LCV-0636-B

VOGTLE ELECTRIC GENERATING PLANT
RESPONSE TO REQUEST FOR ADDITIONAL INFORMATION
INDIVIDUAL PLANT EXAMINATION

VOGTLE - UNITS 1 AND 2
INDIVIDUAL PLANT EXAMINATION SUBMITTAL

FIGURE 1

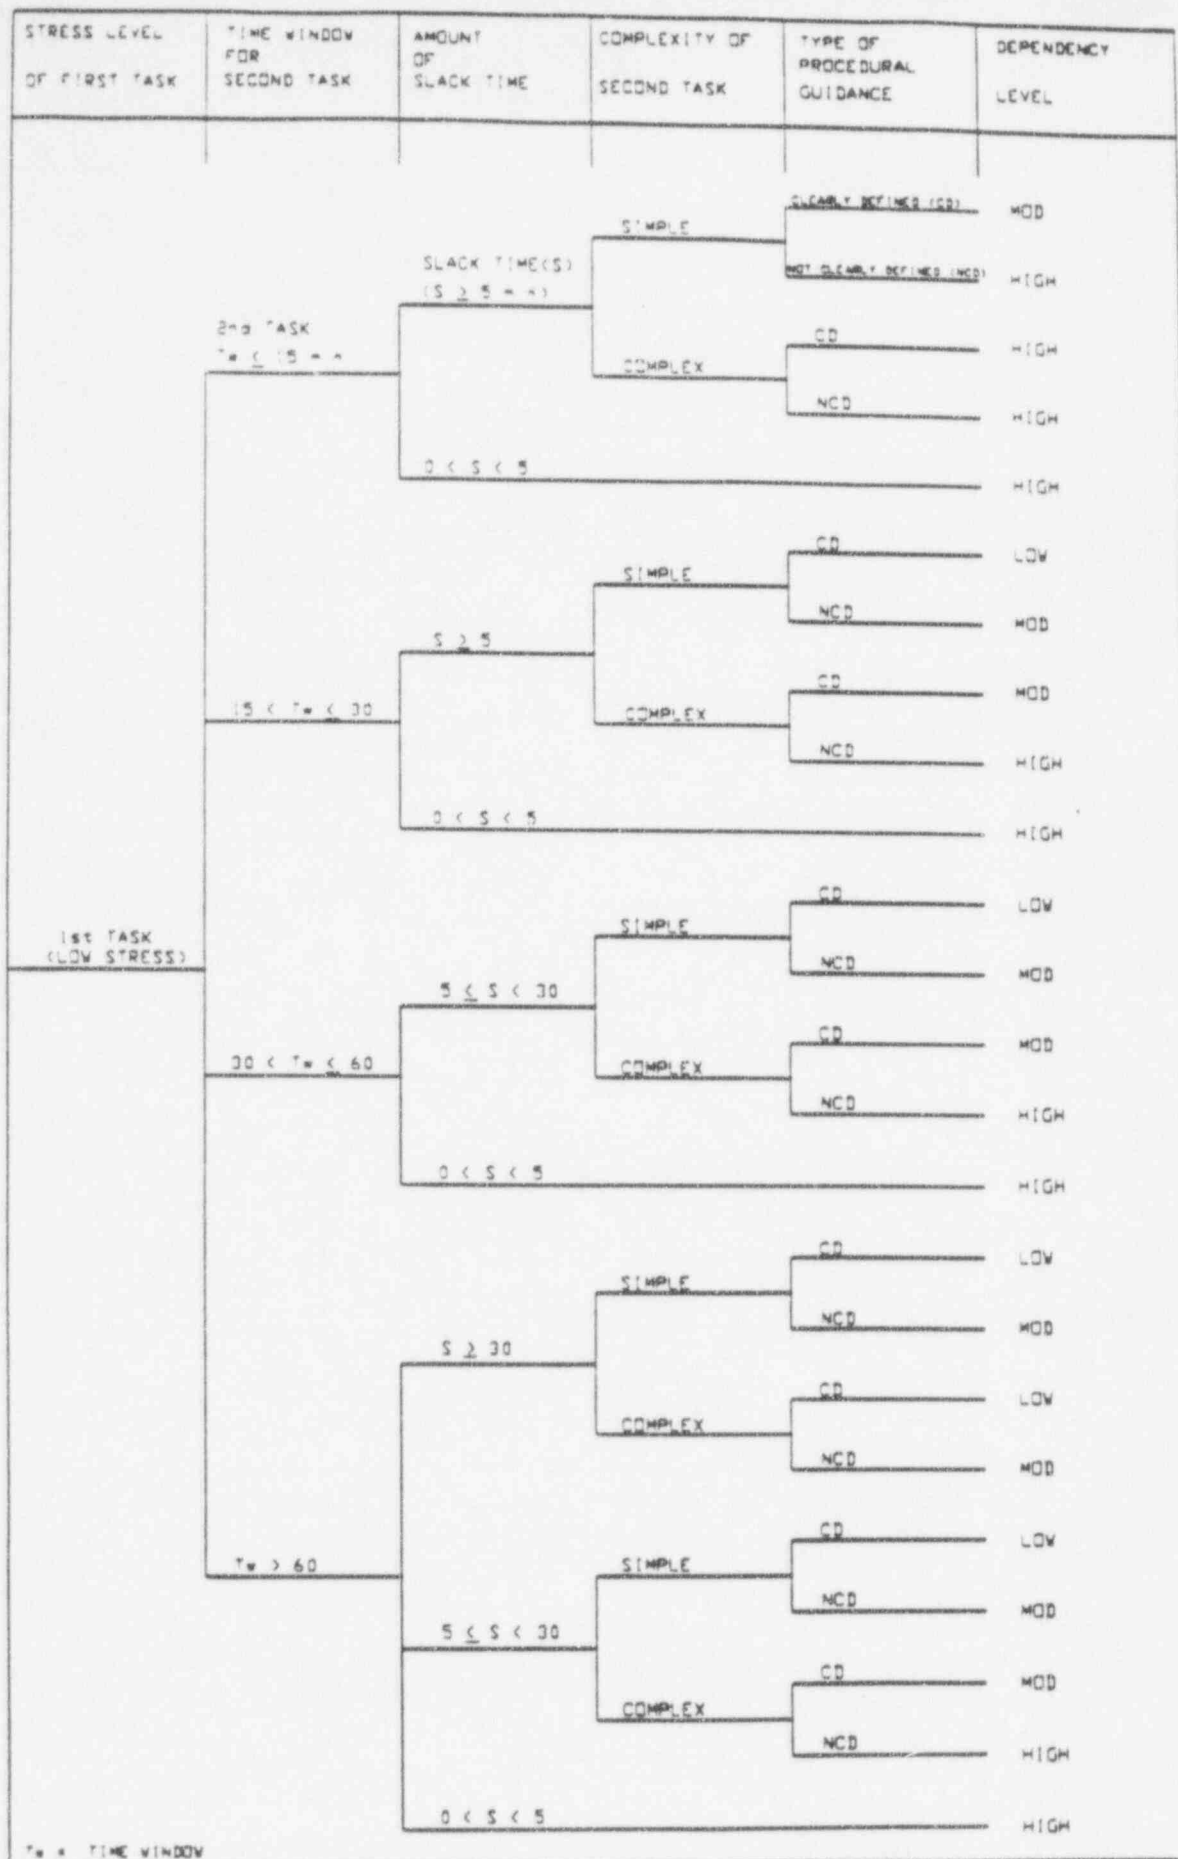
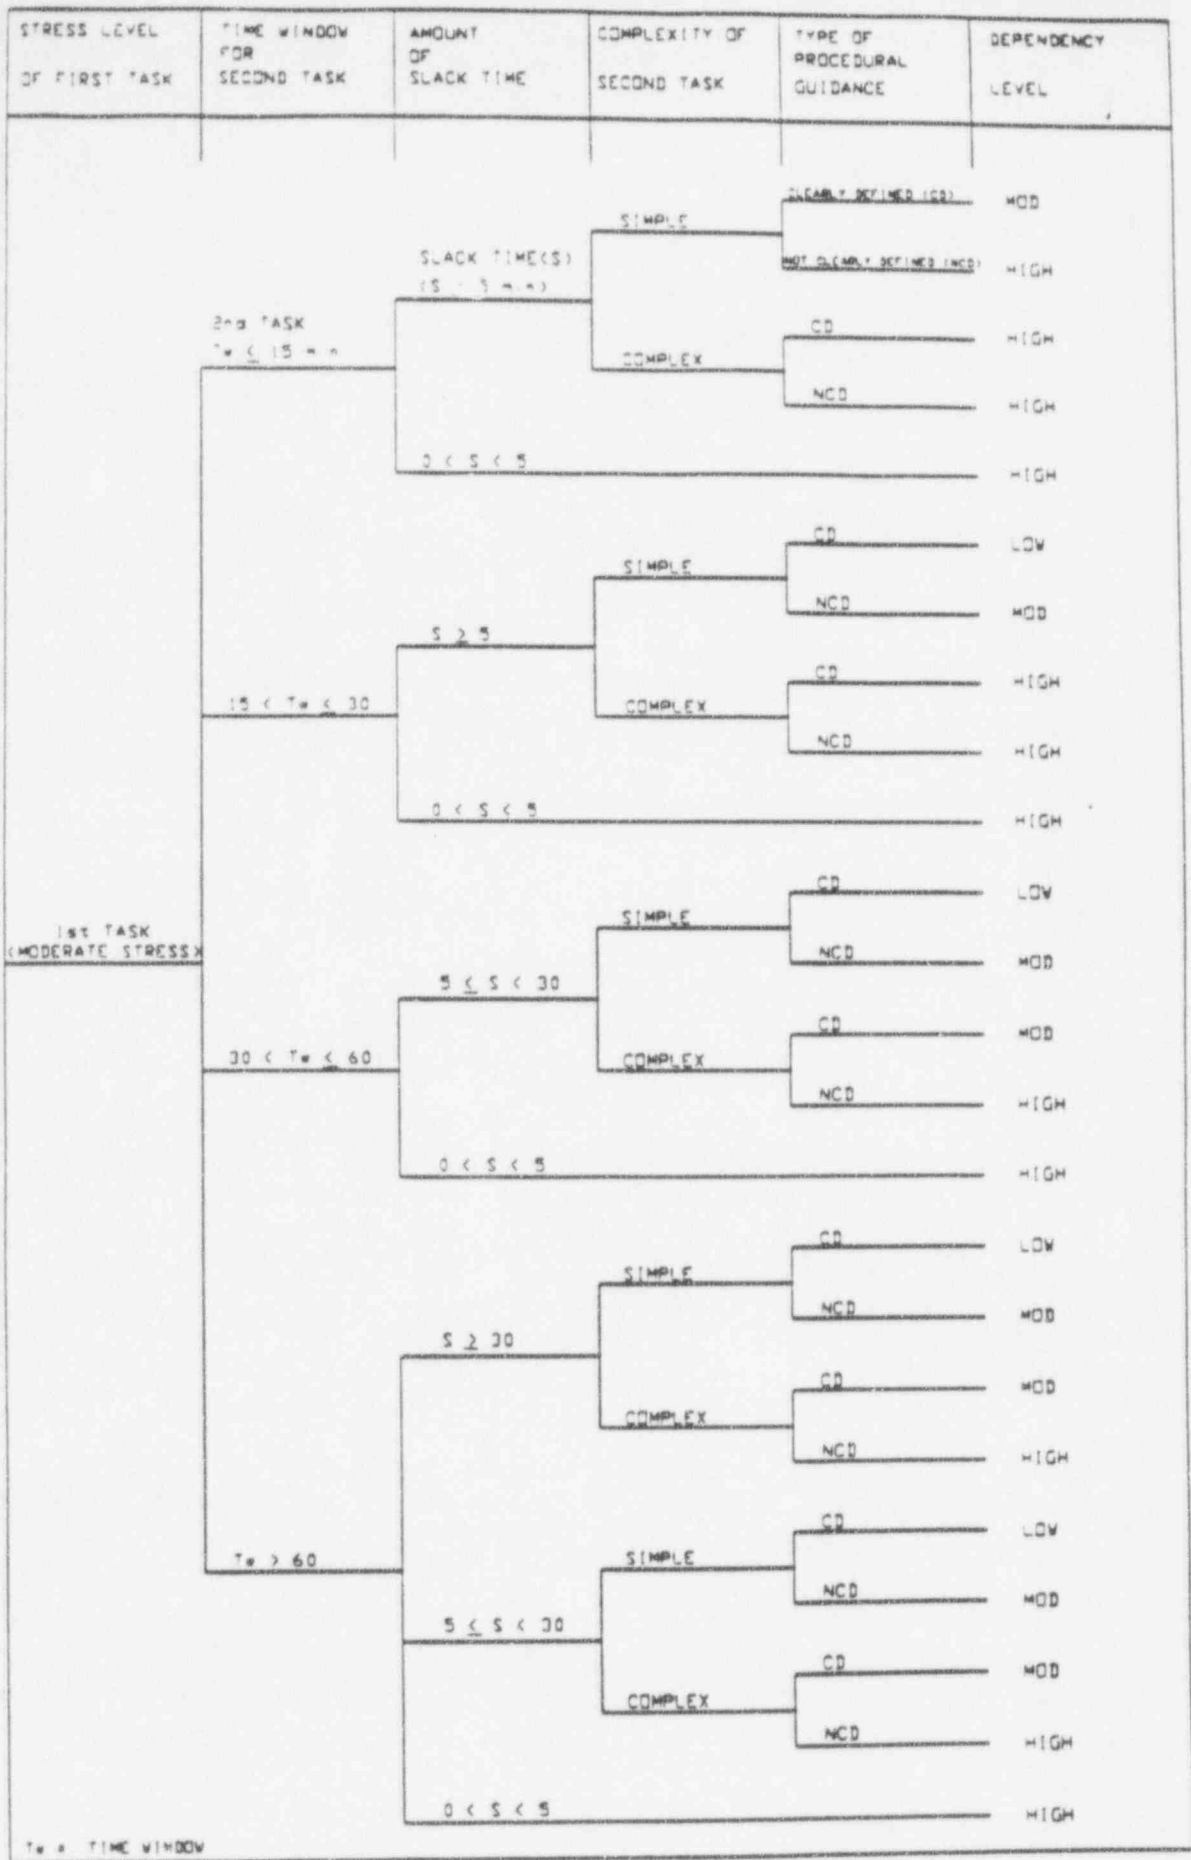
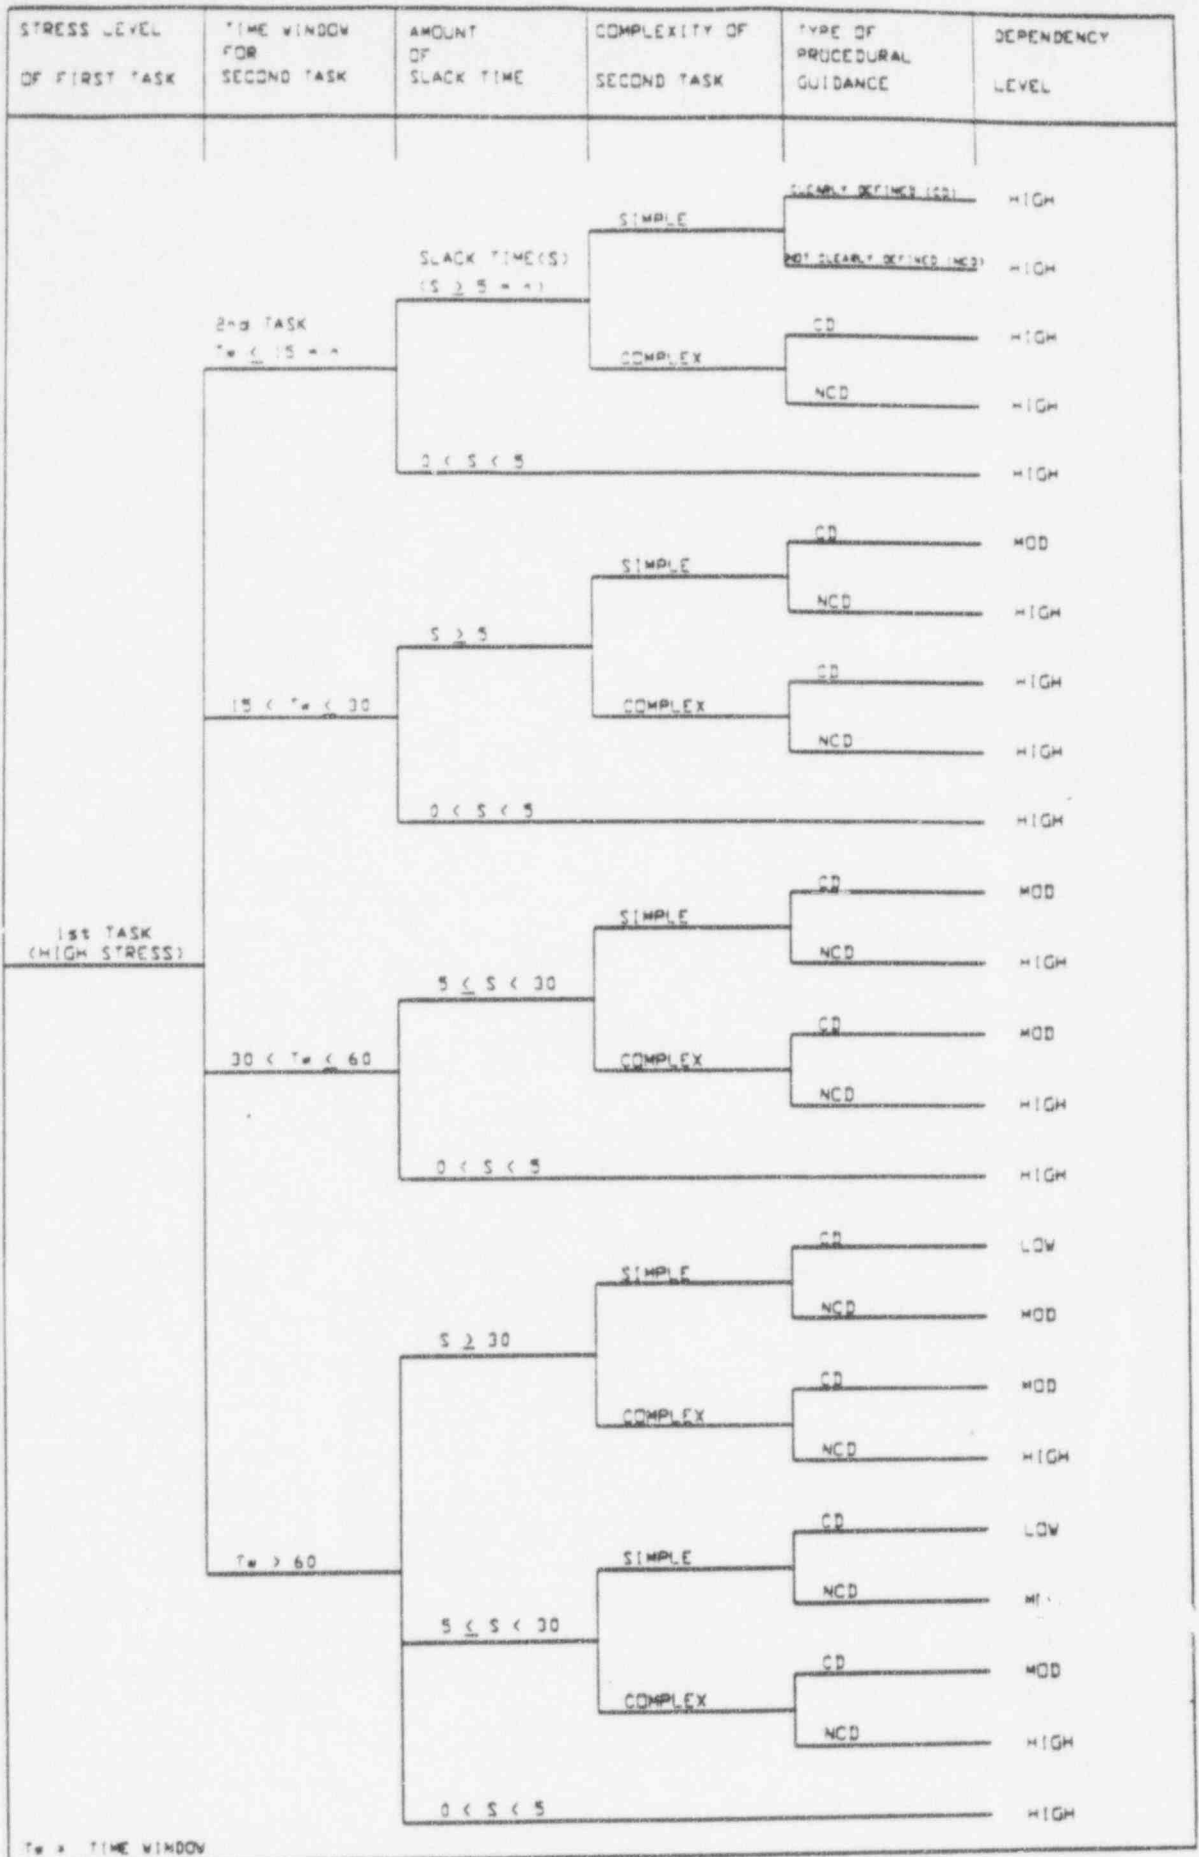
For this type of conditional probability evaluation, the analysis is performed using the event tree provided in Figure 1. The appropriate event tree path, for a given operator action, is agreed upon by the cognizant system analysts and HRA analyst.

The starting point in Figure 1 is to determine the stress level of the first (or preceding) task. If low stress level was used for the first task, then use sheet 1 of 3; if moderate stress was used for the first task, use sheet 2; and if high stress, use sheet 3.

The exercise continues with the aim of determining factors specific to the second task such as time window, slack time, complexity of the tasks (taking into account workload), and the type of procedural guidance. The end result is the deducing of the dependency level for the second task.

Conditional Probabilities are then documented in Table 1 which summarizes and captures the factors considered in Figure 1 for each task.

Figure 5-1 Comparison of Vogtle and Zion cavity configuration.

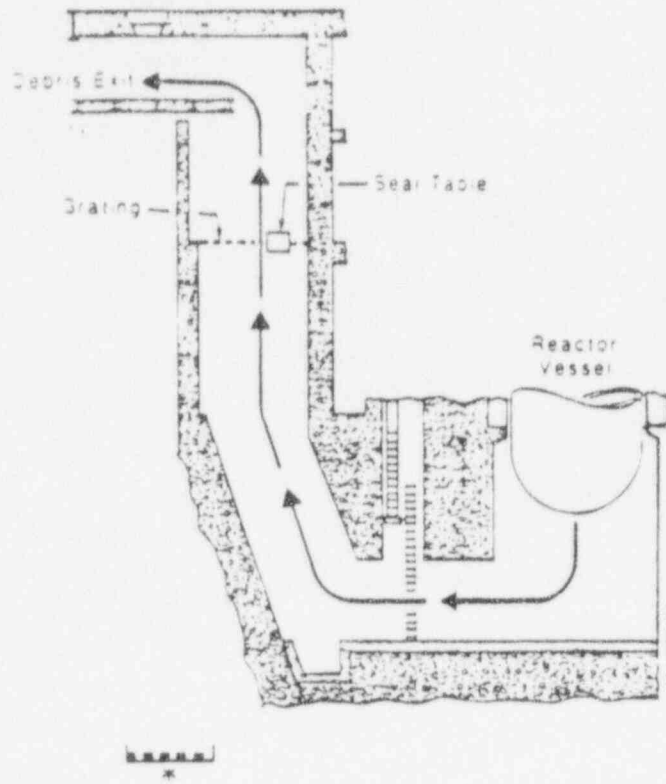
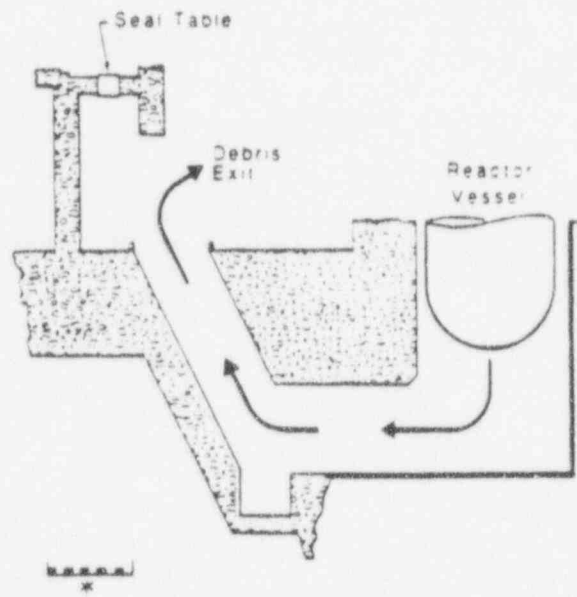
FAI/91-122, "Vogtle Electric Generating Plant Units 1 and 2 Phenomenological Evaluation Summary on Direct Containment Heating in Support of the Individual Plant Examination," provides the basis for determining that only 2% of the entrained debris mass would exit the reactor cavity instrument tunnel and reach the annular compartment. The technical basis is as follows.

Sandia National Laboratory [Walker, 1987] developed a model for estimating the likelihood of debris particles not deflecting with the flow due to a change in flow direction, thus impacting structural boundaries of the flow path. The model was developed for the Zion seal table and instrument tunnel structure where the steam and debris escaping from the cavity makes a 90 degree turn to escape into the lower compartment. An analogous equation was used to describe de-entrainment of debris particles as gas makes a 90 turn to exit the Vogtle reactor cavity.

The Zion and Vogtle cavity configurations are compared in Figure 5-1. The results of this plant-specific calculation indicate that only 2% of the entrained debris mass will reach the annular compartment.

Whereas the model of Walker accounts for a single 90° turn, core debris leaving the Vogtle reactor vessel will have to make two 90° turns before exiting the instrument tunnel to the annular compartment (see Figure 5-1). Also, at Vogtle, there is a concrete platform which extends part way across the instrument tunnel, forming a "lip" which further enhances debris de-entrainment. Thus, the 2% figure obtained from the Walker model is considered to be conservative.
